## ADDENDUM NO: 002

**PROJECT NAME:** BSA GI Lab Renovation

**PROJECT NO.:** 43007.24

**DATE:** September 22, 2025

Reflected Ceiling  
Plan

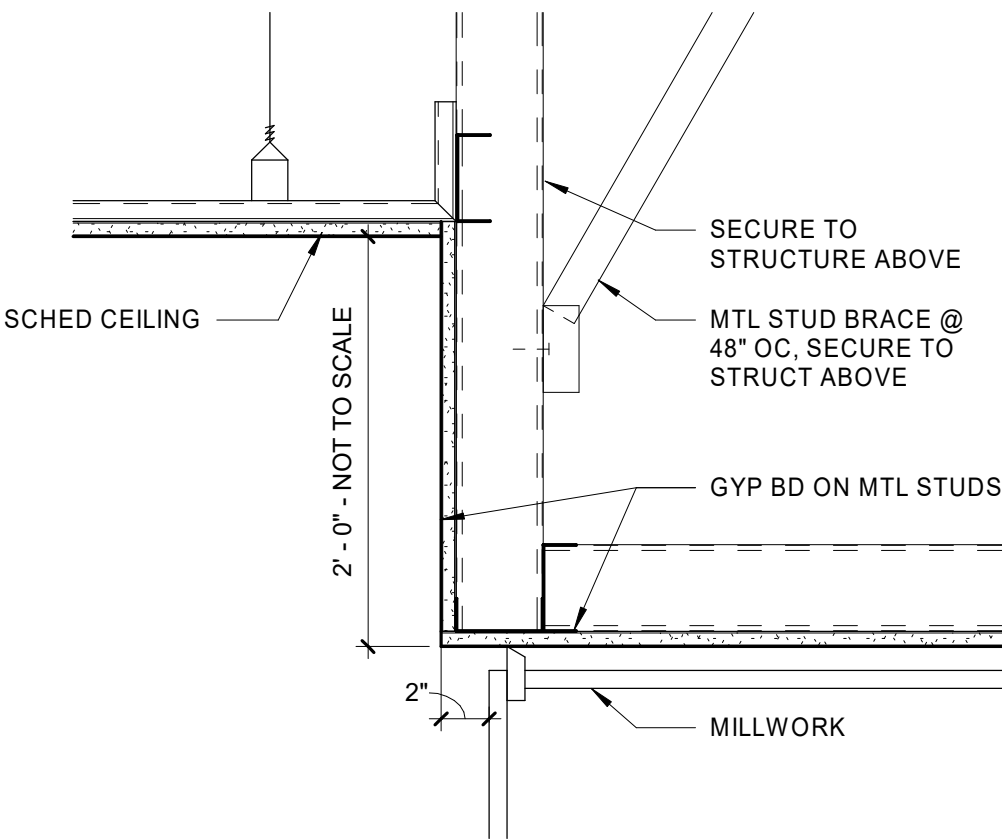
5. SHEET A-131 – Reflected Ceiling Plan
  - a. REVISE to Add verbiage clarifying the required replacement of spray-applied fireproofing for all abated conditions above ceiling.

A1 TYPICAL FRAMING ASSEMBLY  
3/8" = 1'-0"

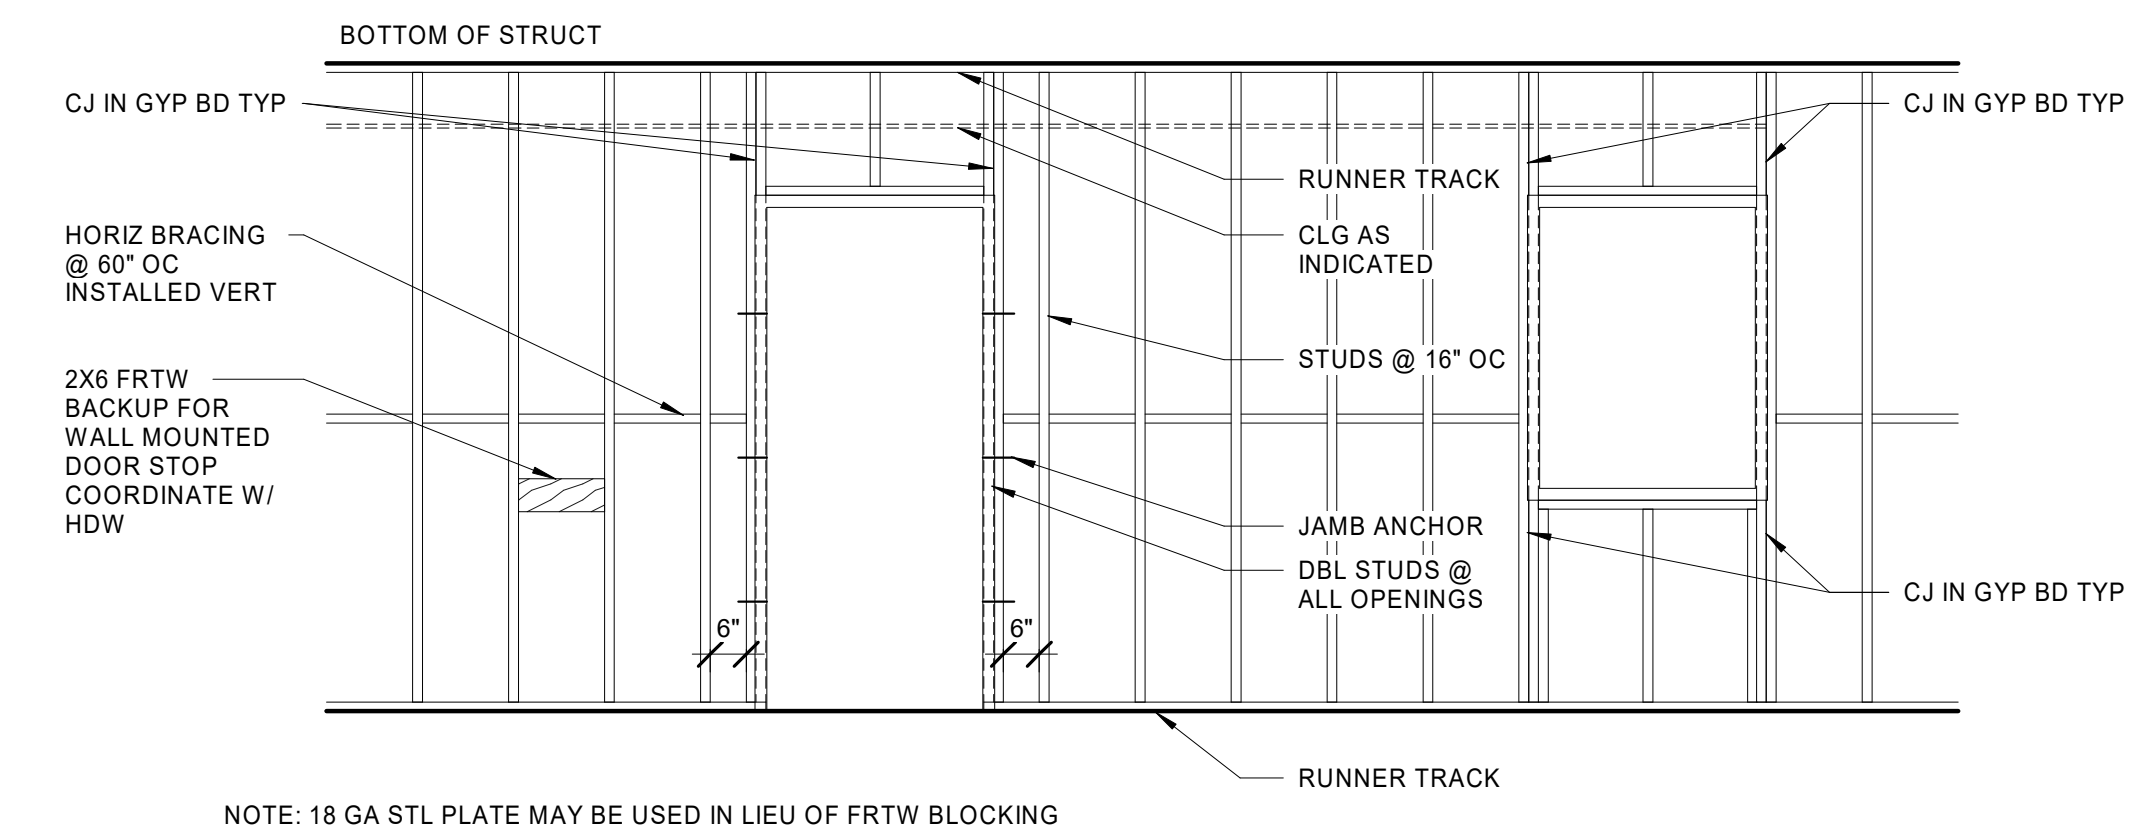
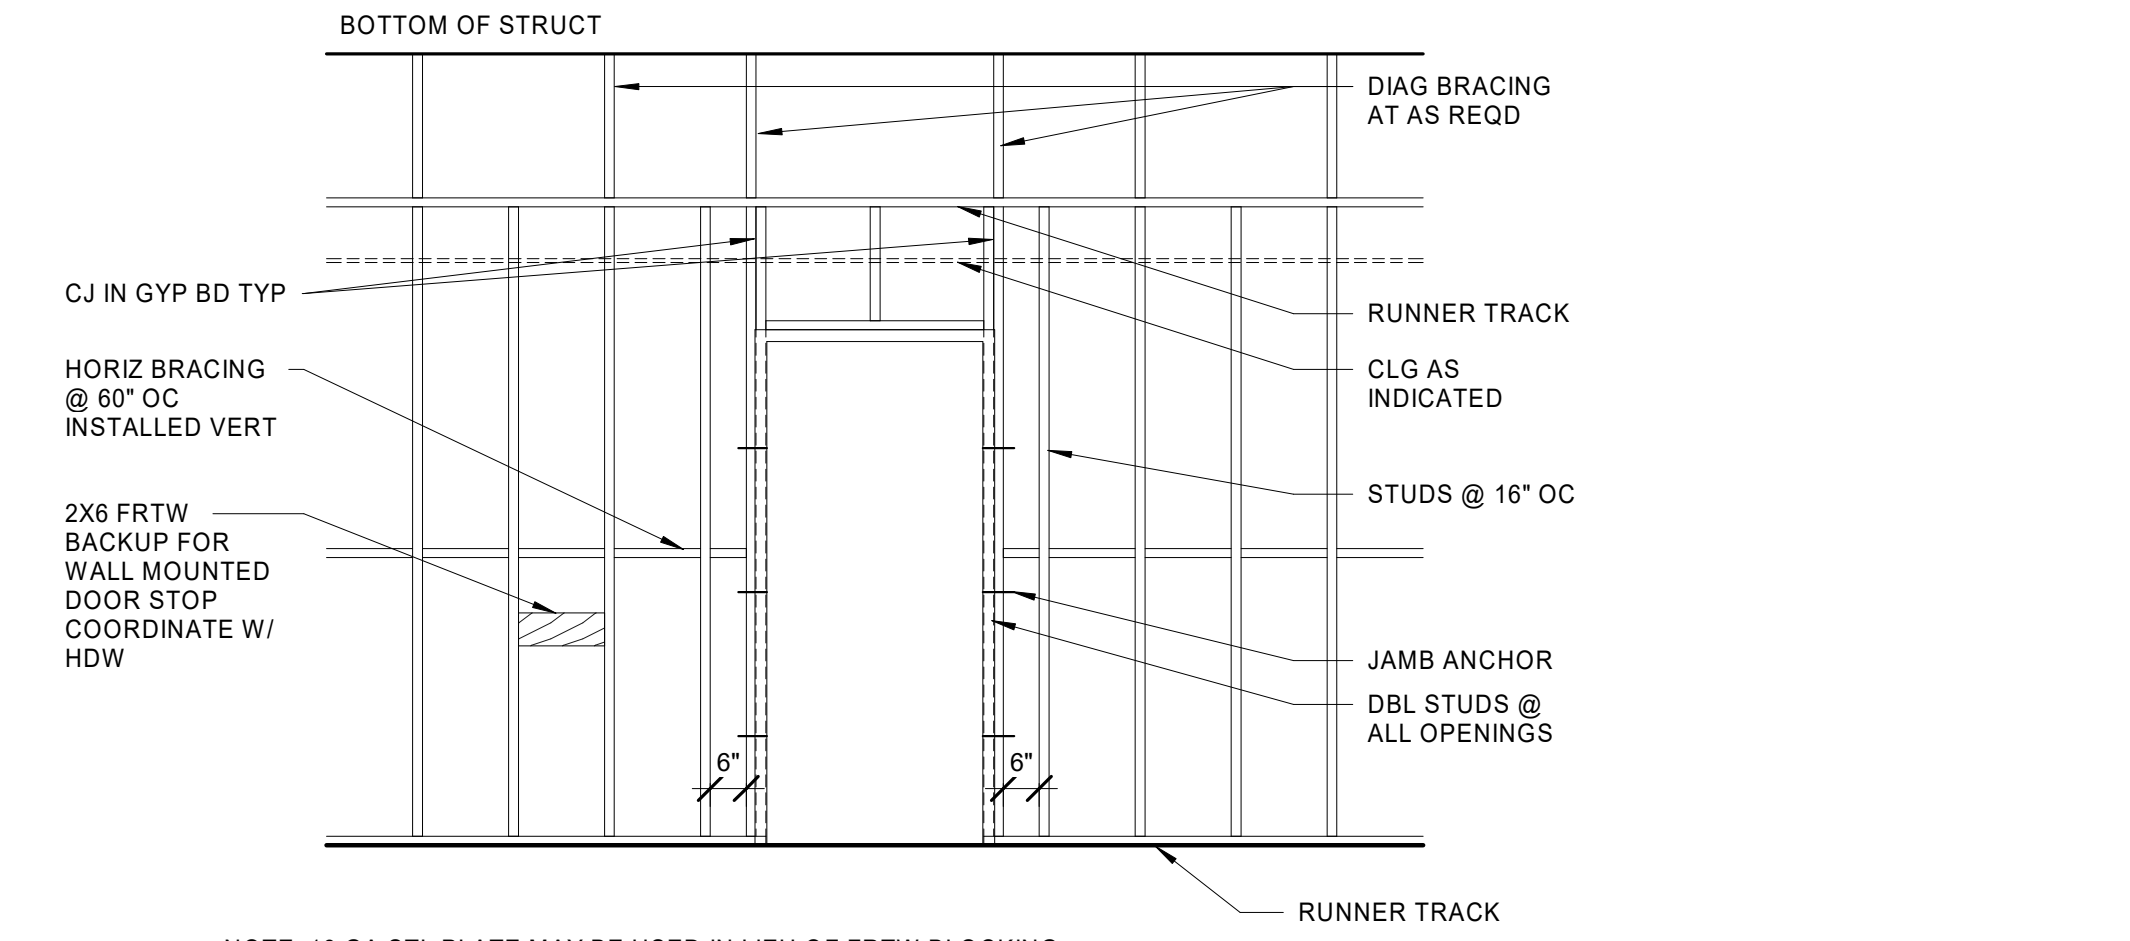
6. SHEET A-601 – Door and Glazing Schedule
  - a. REVISE to Include typical framing assembly details.
7. SHEET A-701 – Interior Legends and Abbreviations
